**Re: Columbia Gas Bangs Facility
NPDES permit: 4IM00100**

Attached is the Reconnaissance Inspection Report conducted by Ohio EPA for the Columbia Gas Bangs facility located at 8284 Columbus Road in Knox County, Ohio and operating under NPDES permit 4IM00100.

NPDES COMPLIANCE INSPECTION REPORT

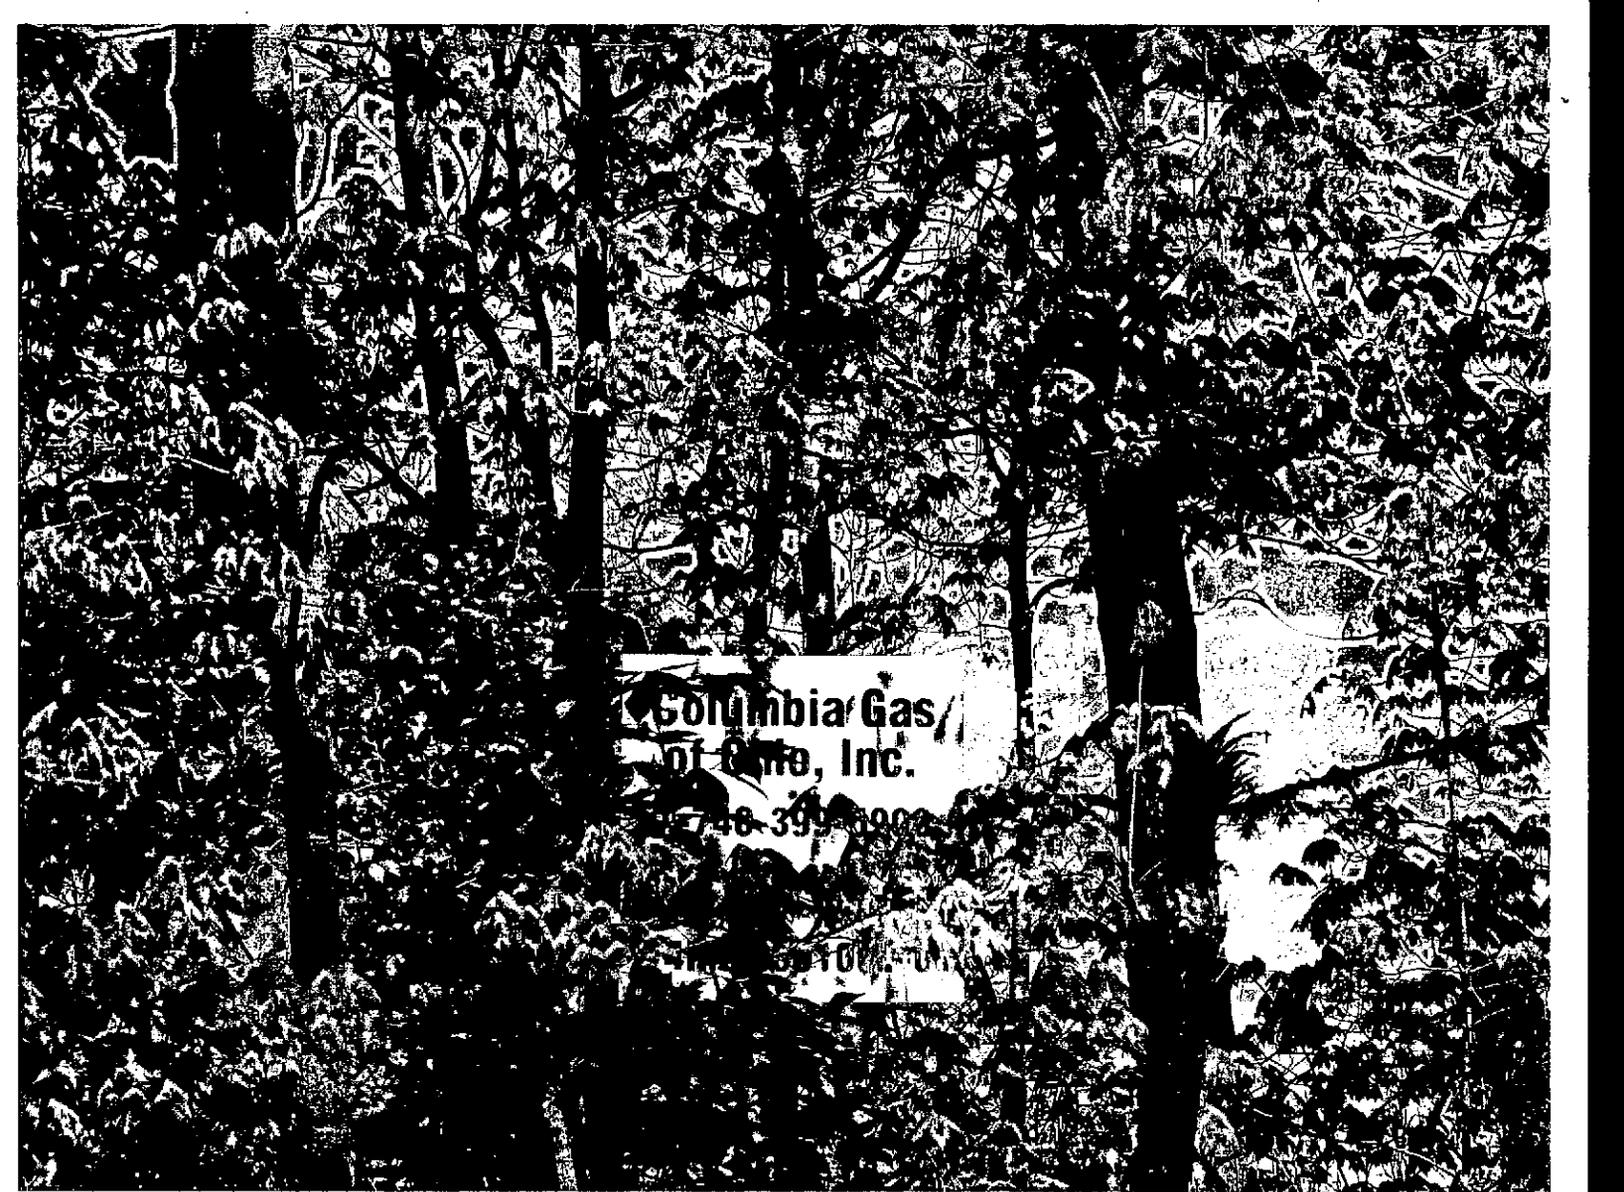
Sign posted indicating outfall is obstructed by leaves. Please trim tree so sign is readable

The permit has a requirement that a sign be posted at the outfall. Columbia Gas has done this. Please note though that in the enclosed picture the tree needs a little trimming to make the sign more legible. **Please indicate in writing when this will be done.**
